Subject: **SBWR Test Program**

Reference: Purdue Testing Meeting, GIRAFFE Testing Program RAIs,
October 1, 1993

Requests for Information by Purdue University prior to
meeting on October 1, 1993.

GE ANSWERS TO PURDUE UNIVERSITY QUESTIONS ON SBWR SYSTEMS

CH. 3/-

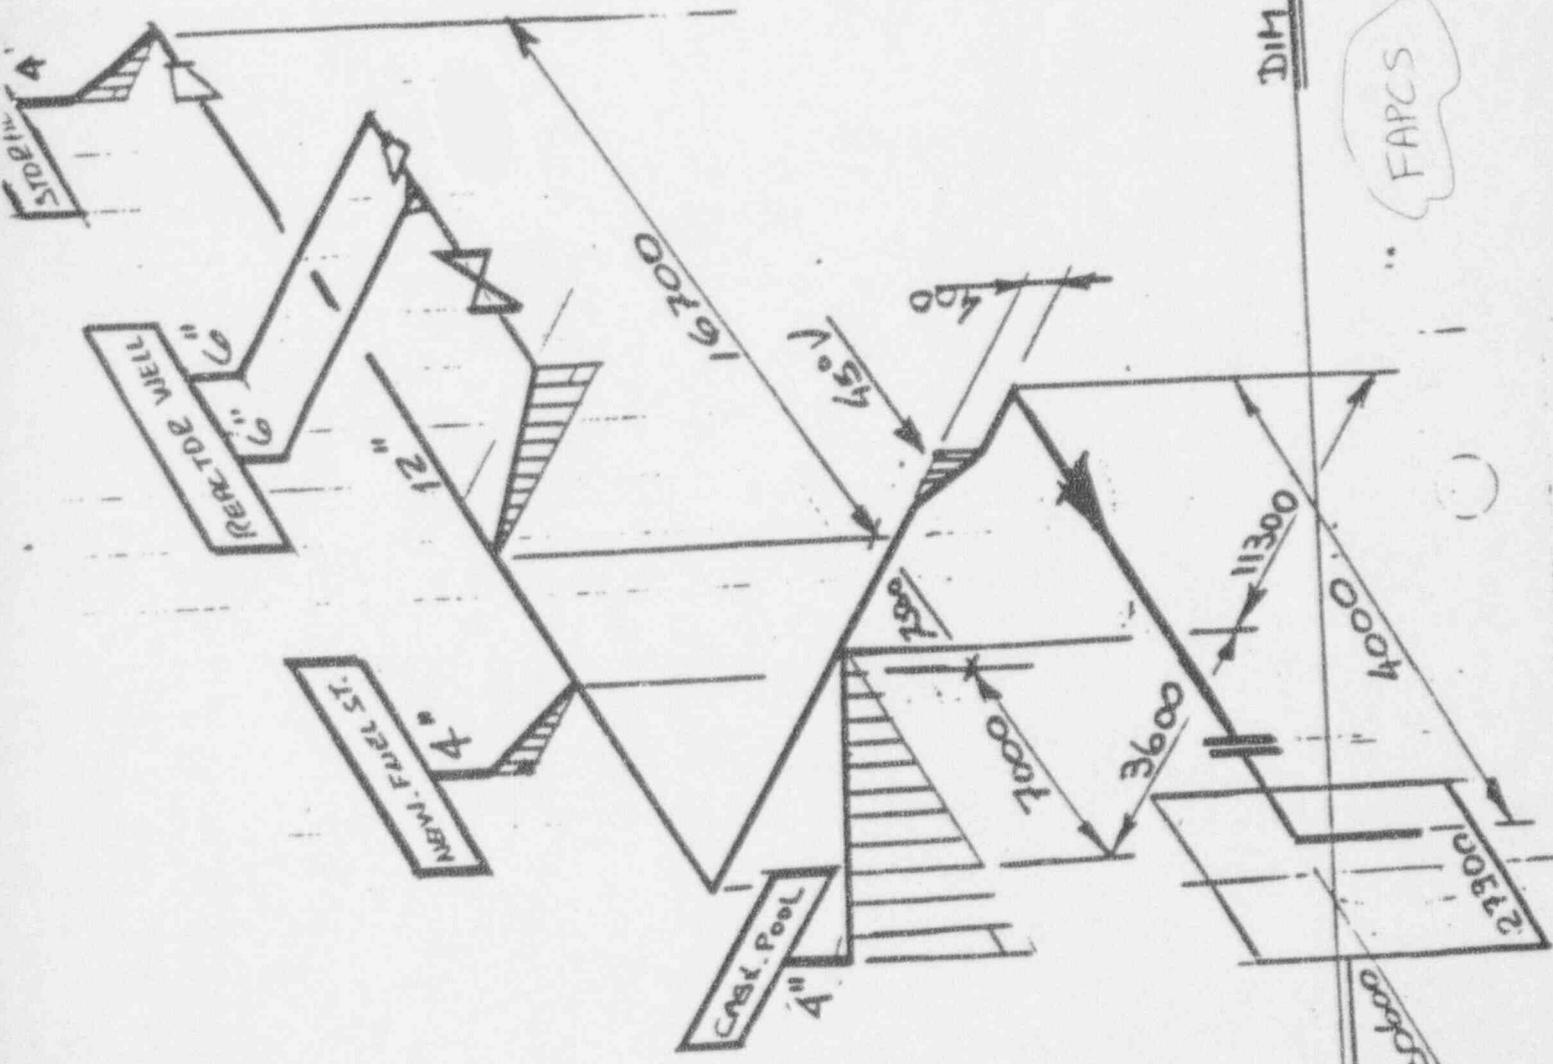
- c. Fuel and Auxiliary Pool Cooling Systems
 - d. Feed Water Lines
7. Can GE provide us with their code calculations of blowdown phase? We are interested in the thermal hydraulic parameters at about 150 sec. After MSL break, information on vessel liquid level (time dependent level due to swelling), quality, void fraction, and exact decay heat power levels will be useful.

- c. FAPCS: see attached isometric drawings (isometric drawings are only available for portions of this system).
- d. FW line: See response to question 1b.

PCC SUPPLY, DRAIN AND VENT LINES

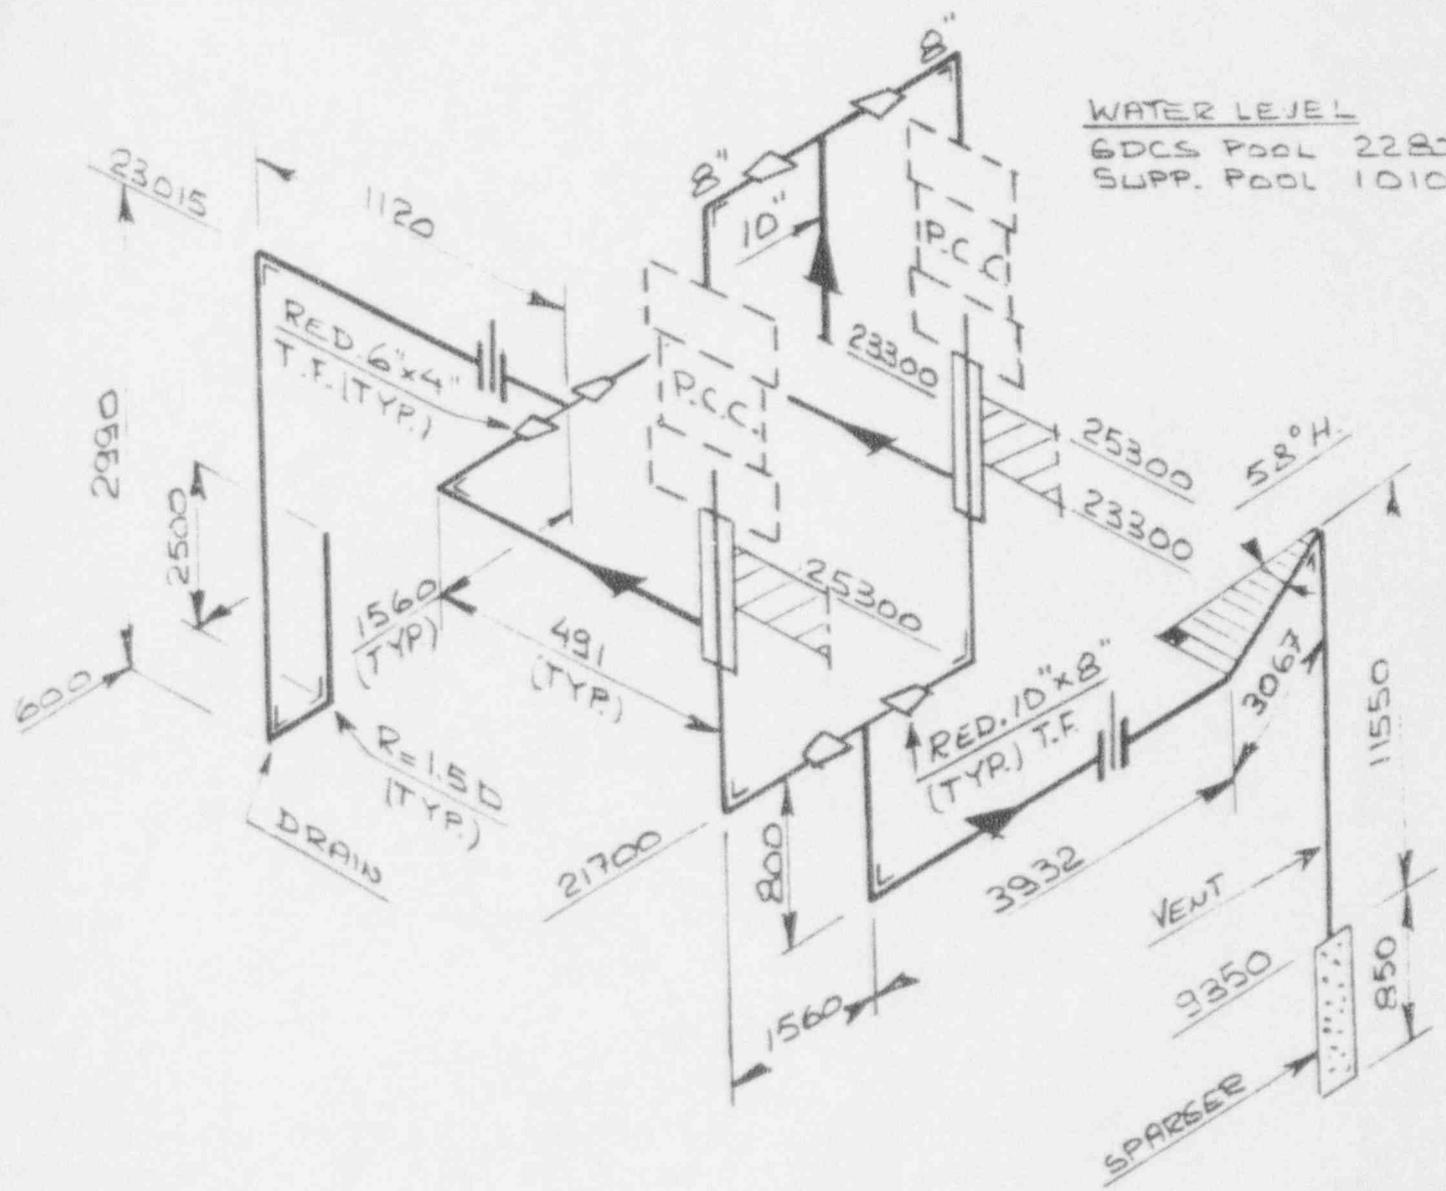
- c. Elevation of the PCCS condensate return line.

Isometric drawing of the PCCS supply, drain and vent lines is attached.
